BOARD OF ARCHITECTURAL REVIEW

WORK SESSION AND BUSINESS MEETING

SEPTEMBER 20, 2023

TLHPBR2023-0016

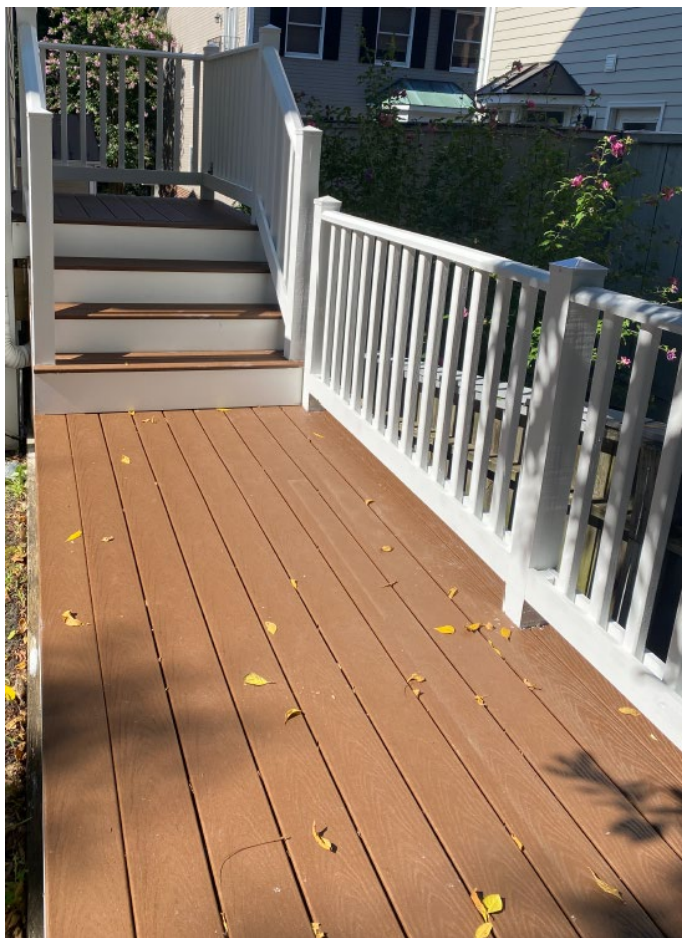
- Previous stairways and deck were all wood construction
 - Stairs and decking are Trex with unpainted ends
 - Trim pieces are Versatex painted white
 - Railings and structure are wood
- The Guidelines prefer in-kind repair and replacement of such elements
 - Contemporary materials consistent with the visual characteristics of wood are permitted for non-contributing structures within the H-I.
 - Trex and Versatex have both been approved for similar installations; however, the raw ends of the Trex material should be hidden in some fashion.
 - The applicant has proposed to paint the ends to match the finished sides. A sample will be provided, and discussion is recommended.

1. The ends of the raw composite decking material will be painted to match the finished sides on the front stairs and landing, rear stairs and landing, and rear deck.

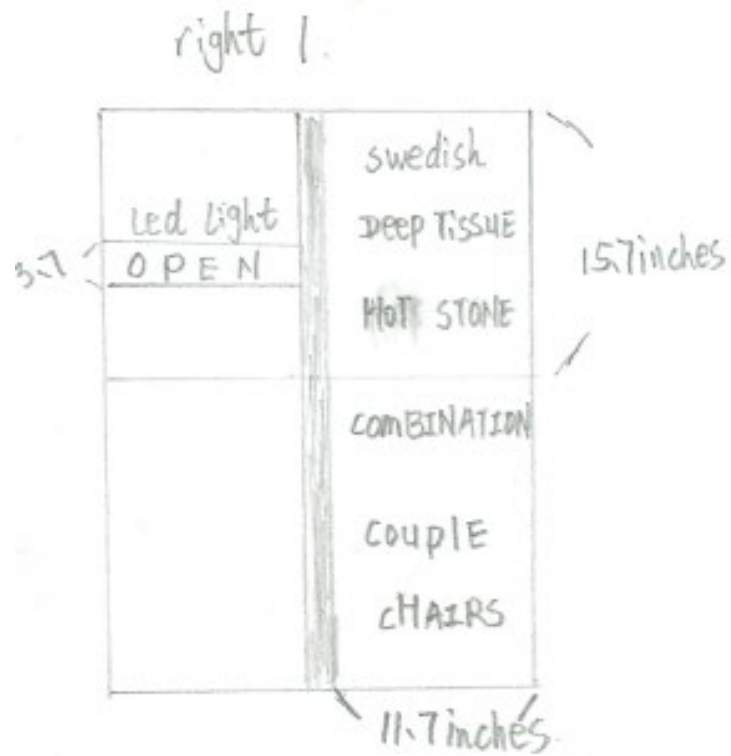
- Zoning Ordinance allows BAR to grant extra signage when architectural character warrants
- Staff supports the third sign request given the basement location with rear entrance and because the front door doesn't access the subject suite.
- Wall/Projecting sign – wood, generally appropriate. Staff recommends approval as shown unless the signs require enlargement to address concerns about the window signs.
- Window Signs – staff does not find consistent with the Guidelines.

- Window locations in English basement (not a traditional storefront)
- Unclear if 20% guideline is met (no sizes provided for window letters) but appear to exceed
- Extensive messaging including services offered
- Lit open/massage signs prohibited by zoning ordinance but are also inconsistent with historic leesburg character.

- a. The composition of the sign will be reduced to occupy one 4-pane window and will contain the minimal information needed to direct customers to the location of business and its entrance.
 - b. The window sign will be approximately ____ square feet. With letters no more than ____ inches tall.
 - c. A revised design will be provided to the Preservation Planner for final approval prior to application for a sign permit.”

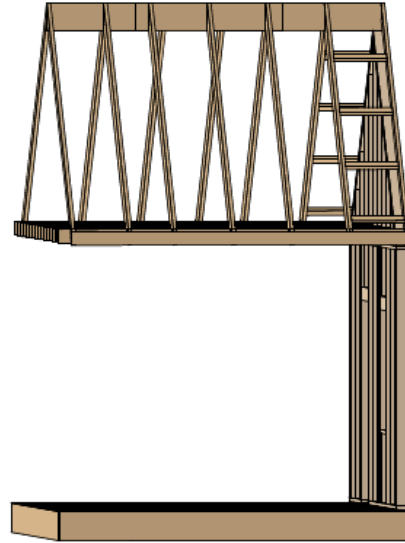
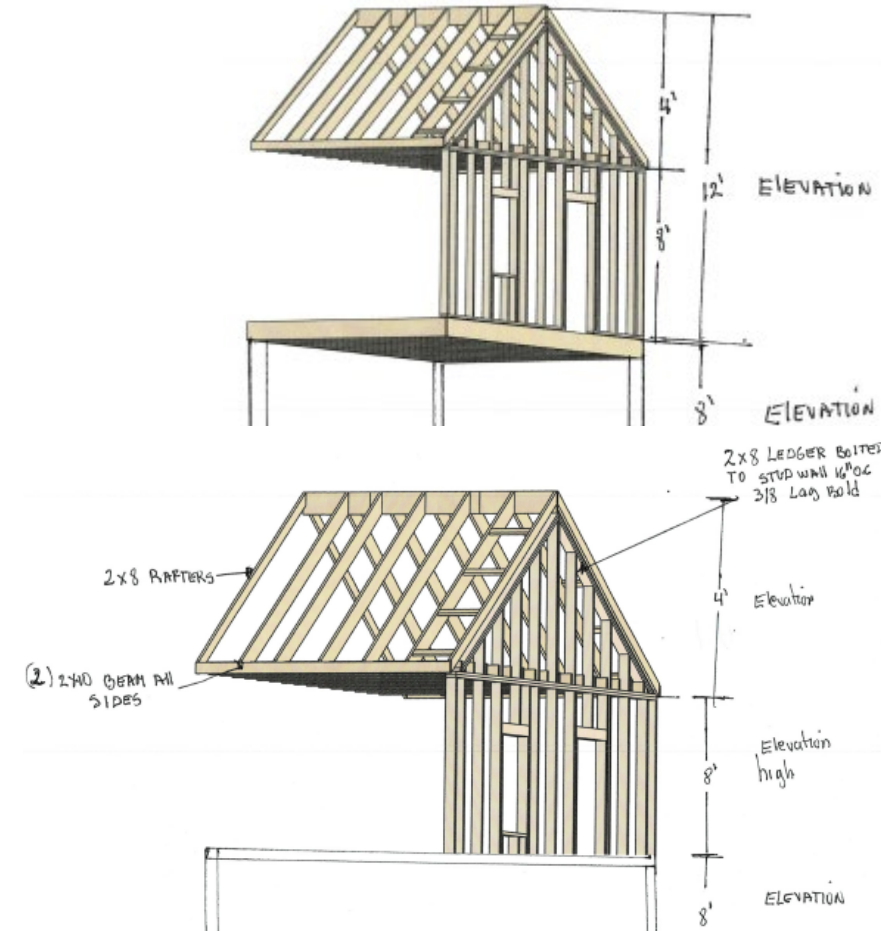
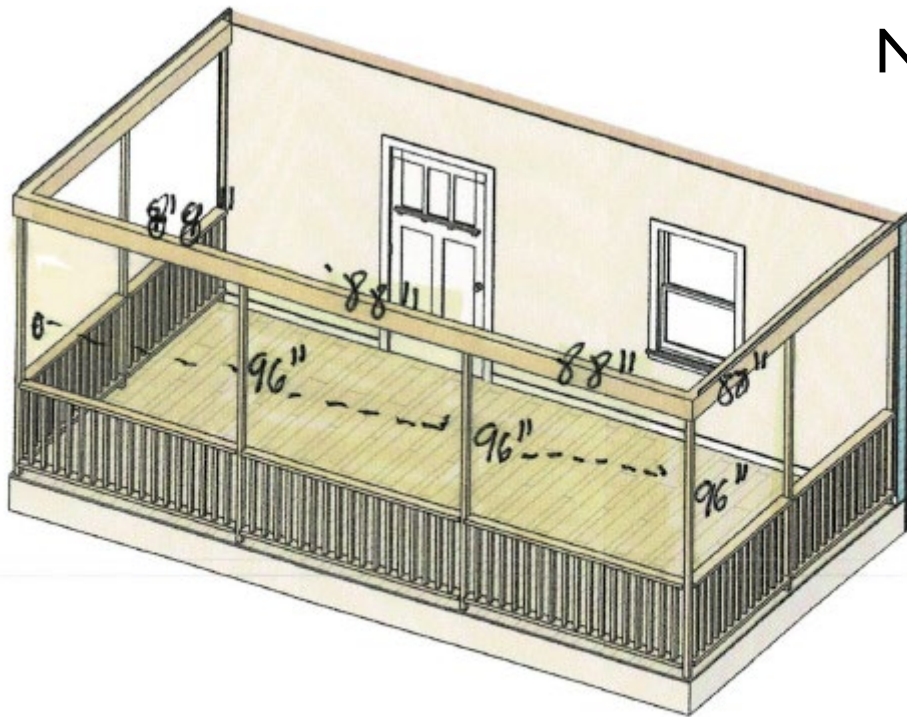
Submitted screen porch dimensions and description
No information provided about Sunscape

- Trim material
- Materials/dimensions of roof
- Sunscape description/specifications
- Eze-Breeze description/specifications
- Dimensions of all elevations of screen porch
- Dimensions/locations/material of fenestrations on screen porch
- Dimensions of railings on porch and stairs
- Drawings depicting how the screen porch will attach to primary structure

- a sample of the proposed screen system
- clarification of the proposed door material
- drawings which clearly show how the proposed sunroom will attach to the existing house
-
-
